# Installation Instructions

## #443 Strike with 1310 Mullion

### Important Installation Note:

1310 x 443 Factory Prep prior to 3-1-2010 for 5300 rim exit device

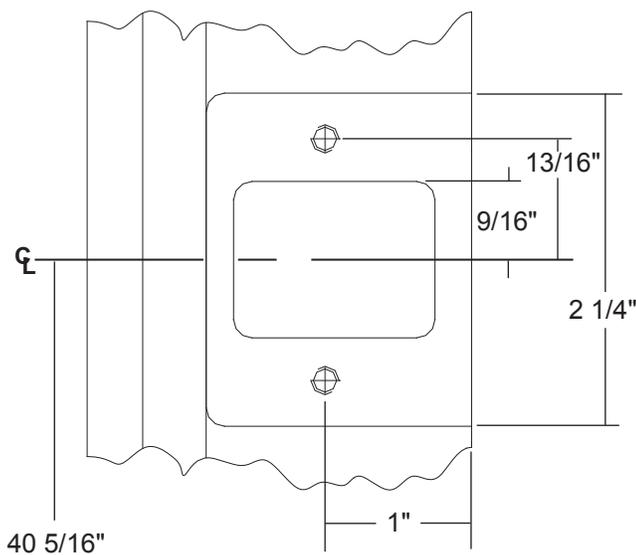
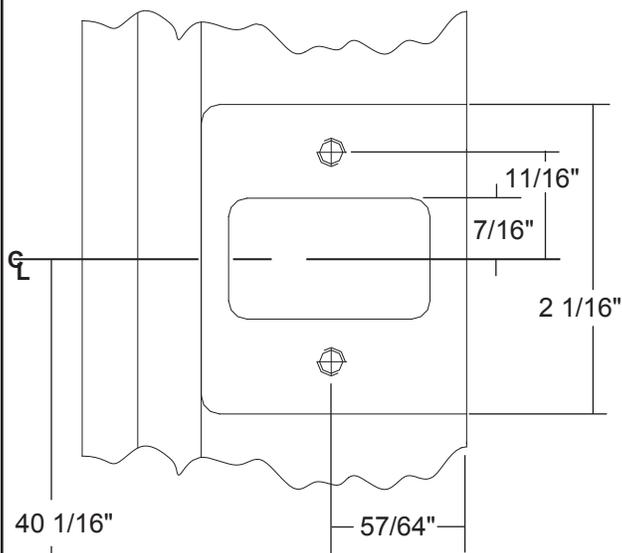
DORMA made a change to the #443 strike implemented on production of 1310 series mullions manufactured after 3-1-2010 to accommodate the 9700 narrow stile rim exit device and the 9300 series rim exit device. Due to the horizontal center line of the 9300 and 9700 exit devices being 1/4" higher than the 5300 series the "cut out" prep in the mullion had to be raised. To accept the larger latch bolts and dead latch design of the 9300 and 9700 series exit devices the "cut out" also had to be increased. The 443 strike manufactured after 3-1-2010 will still accept the latch bolt of the 5300 series exit device for strike replacement (new mounting holes required).

Use existing center line. Machining of the existing mullion will be required. See details below:
